# CSV ARCHITECTS

Re: Application no.: A22-003792 – 78 Rosemount Avenue

**78 ROSEMOUNT AVE.**

**CODE MATRIX**

A004

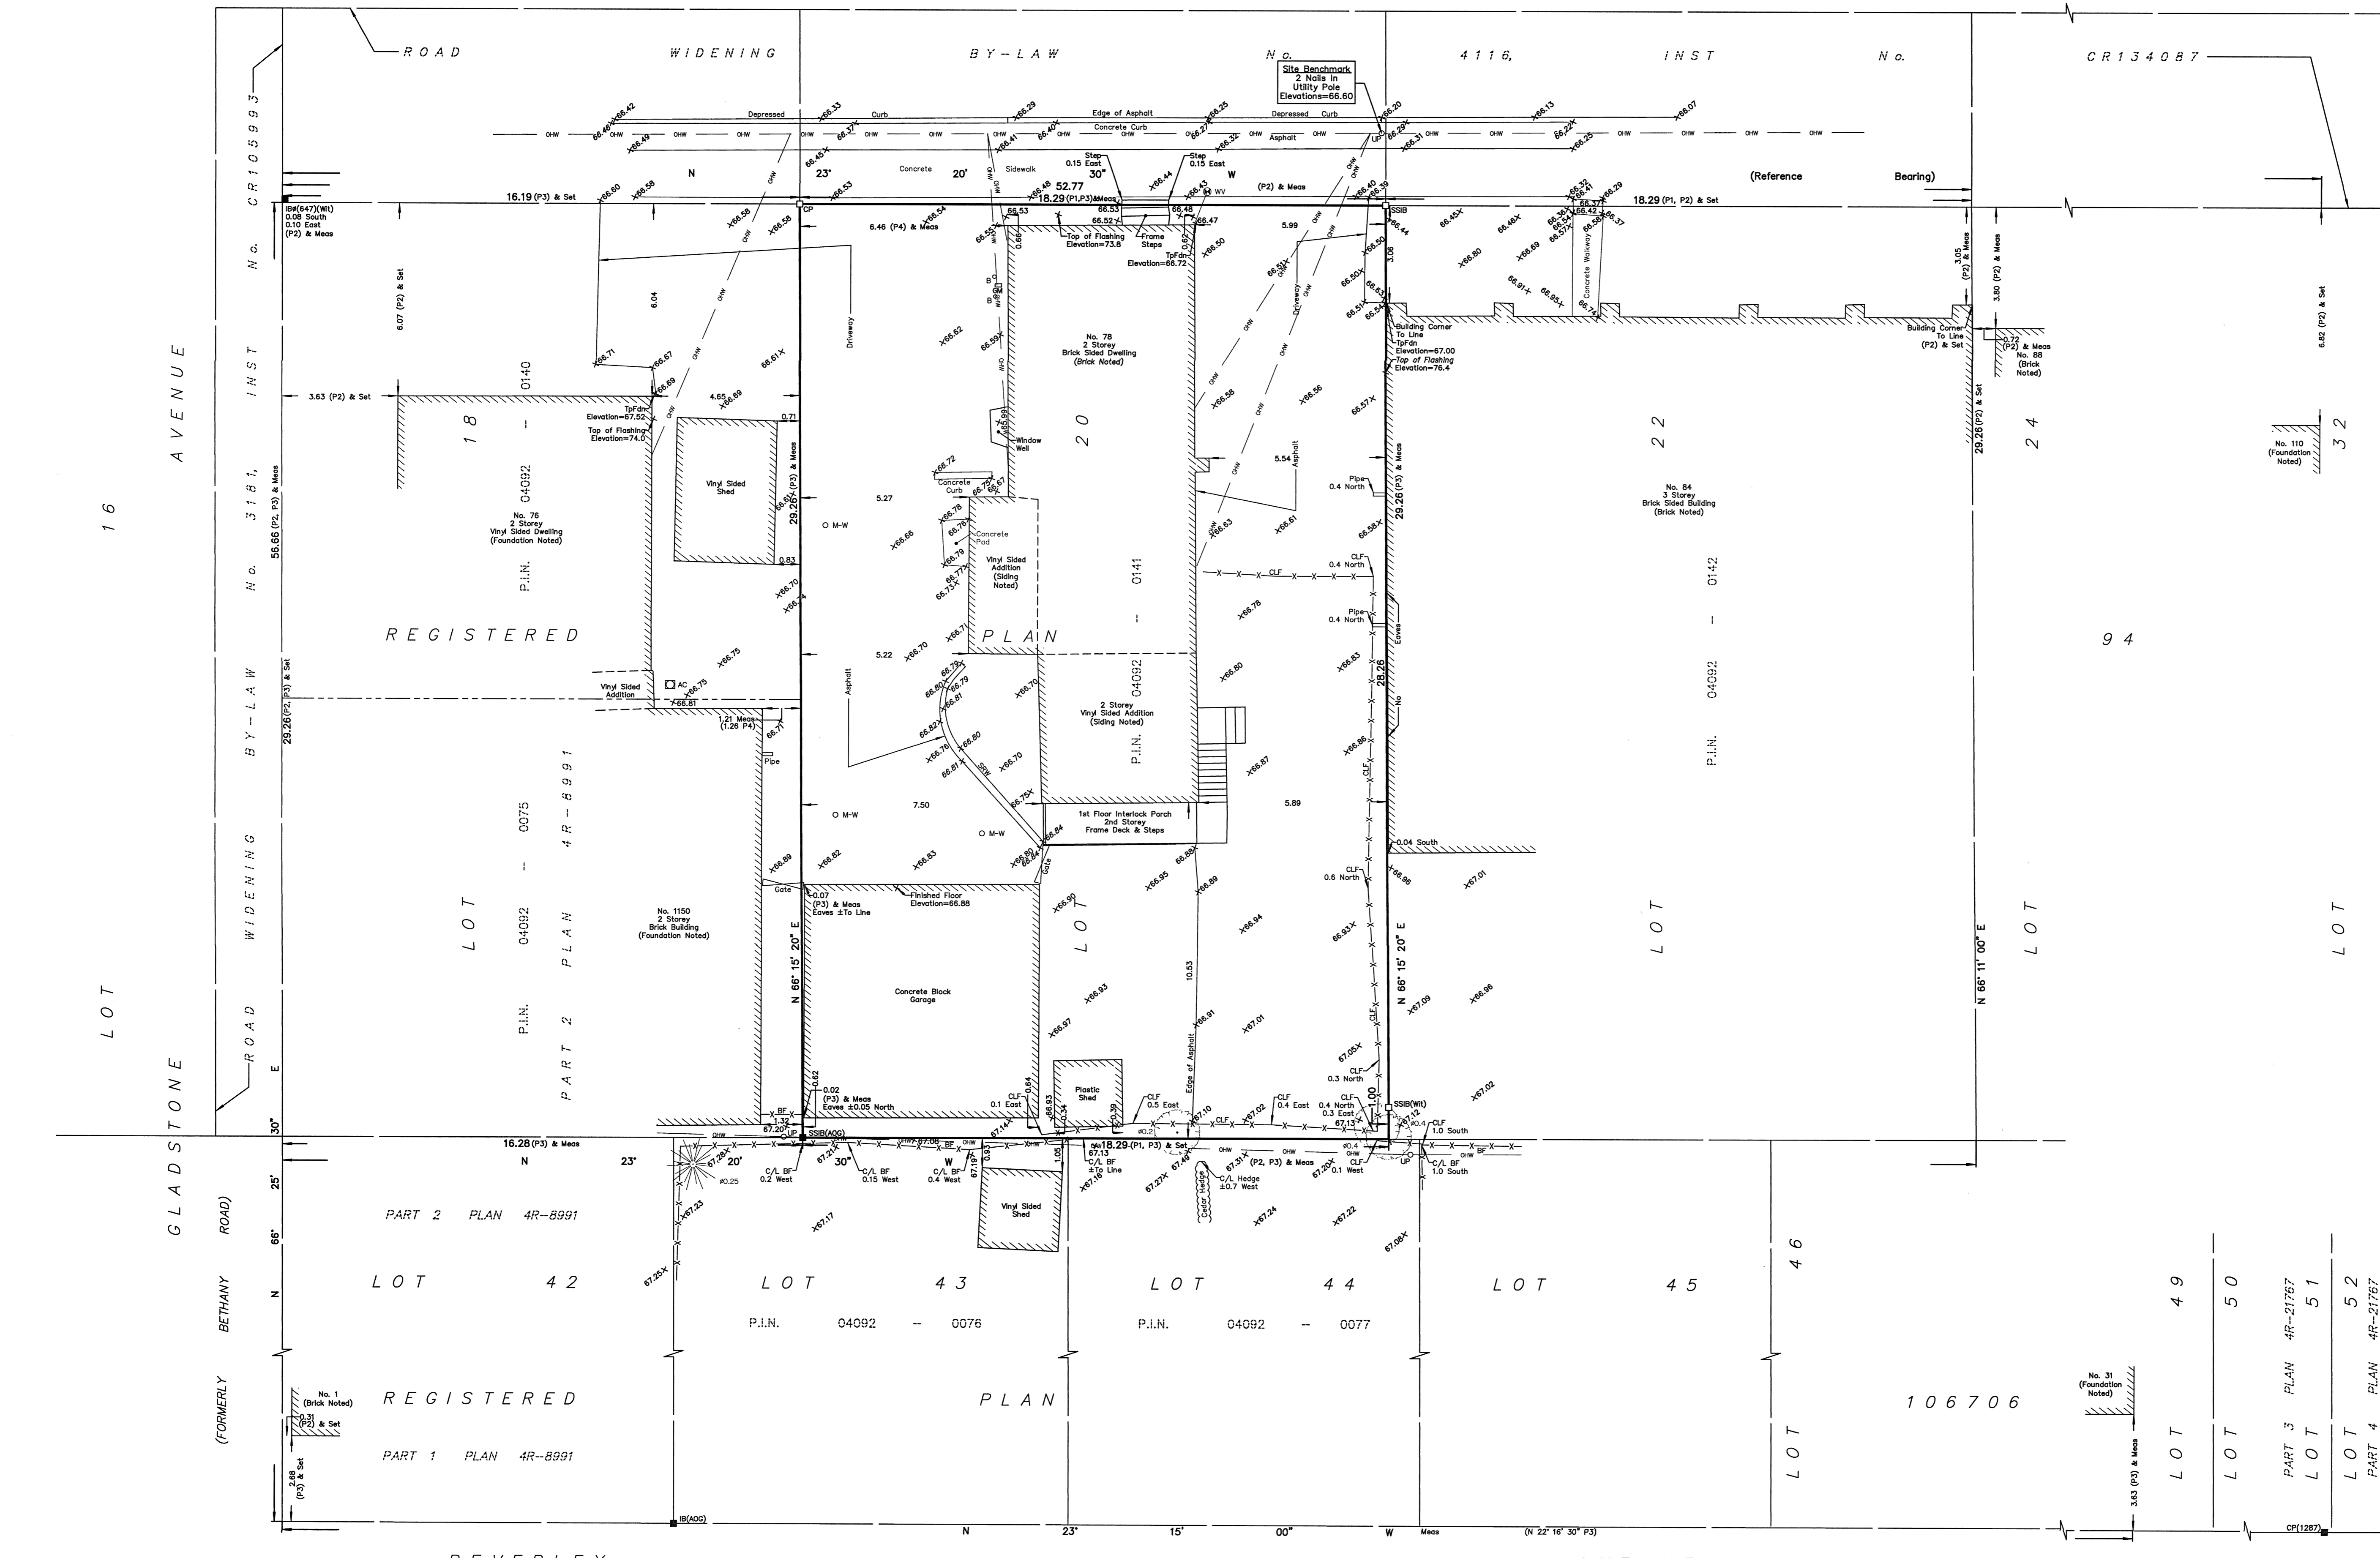
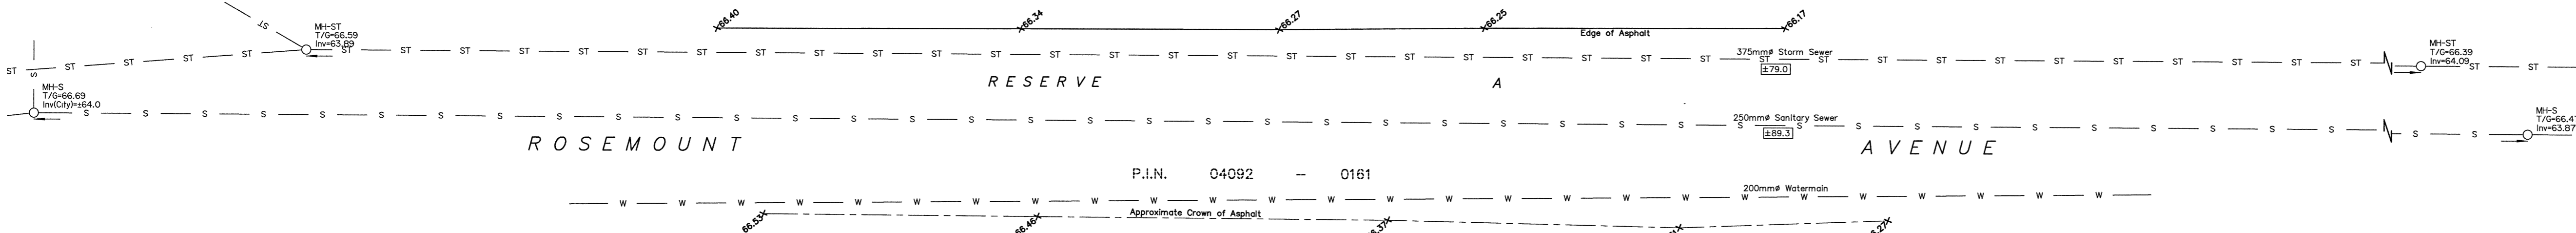
4. Please see the revised elevation drawings attached indicating the min. 25% window amount.

$66.58 + 66.85 + 66.95 + 66.54 = 266.92 / 4 = 66.73$ . We are adjusting the building height by 19mm to accommodate. Please see the revised elevation drawings for where this mark is located.
